Re: Rocky Reach Hydroelectric Project No. 2145
License Article 401 – Final Total Dissolved Gas: Step One, Year
Five Compliance Report

TOTAL DISSOLVED GAS: STEP ONE, YEAR FIVE COMPLIANCE REPORT

**ROCKY REACH HYDROELECTRIC PROJECT
FERC Project No. 2145**

APPENDIX A: RESPONSE TO COMMENTS

Figure 3-1: Mean daily discharge values as measured at Rocky Reach Dam.

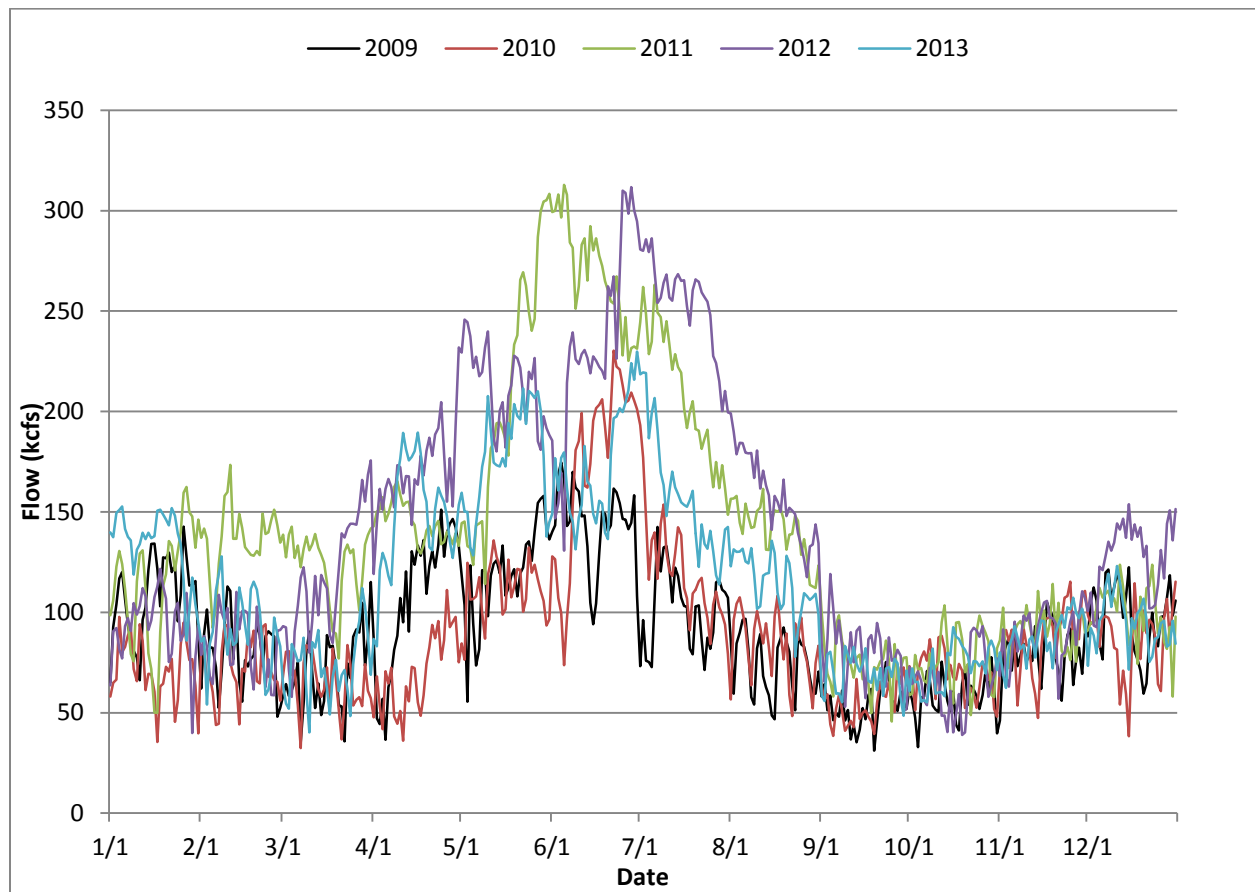
2.	Figure 3-1 doesn't appear to support this statement. From Figure 3-1, the flows during 2011 Jan. - March period appear to be higher than 2012 and 2013. Additionally, flows in all years during Jan. - March were less than the 7Q10 flow, so why the exceedences? Is it entirely related to flow as stated, or did the power market have an influence as well?	<p>Upon review of the comments submitted by Kirk Truscott, an error in Table 3-3 was discovered. The error in the table was regarding the total number of days of data recorded for the 110% criteria. The number of days reported were correct, but the 110% TDG criteria is reported in hours, thereby reporting an incorrect % of time below the 110% criteria. The table has been changed to reflect total number of "hours" of data recorded and the % time below 110% corrected to reflect these hours as opposed to days.</p> <p>In response to the comment, the section has been corrected to describe the appropriate condition that created the 110% exceedances during the January through March time period in 2012 as described below:</p> <p>During the non fish-spill season, TDG levels were notably higher in the last few days of March in 2012. In a three-day period from March 29 through 31, 2012, there were a combined total of 113 hourly (52 hours Rocky Reach tailrace and 61 Rock Island forebay) exceedances of the 110 percent criteria. During these three days, a federal operations spillway test occurred at Chief Joseph Dam (CHJ) upstream of Rocky Reach which created unusually high river flows into the Project. Additionally, one of the generating units at Rocky Reach was out with unavoidable maintenance thereby reducing the generation capability. During these three days, CHJ conducted a spillway test requiring the Project to spill at a 60 kcfs level over and above its normal turbine generating flow (J. Taylor, Mid-C Hourly Coordination Coordinator, 2012). The CHJ spill test required Grand Coulee dam (GCL) to increase discharge to maintain CHJ reservoir elevations during the spill test, and non-federal Projects to pre-draft their reservoirs in order minimize system-wide spill from all Mid-Columbia Projects resulting from increased river flows. The spill test increased inflows into all down river dams in the Mid-Columbia. Mean daily total discharge and spill for Grand Coulee, Chief Joseph, Rocky Reach and Rock Island are represented in Figures 3-2 and 3-3 during the periods when the 110 percent exceedances occurred at Rocky Reach tailrace and Rock Island forebay.</p>
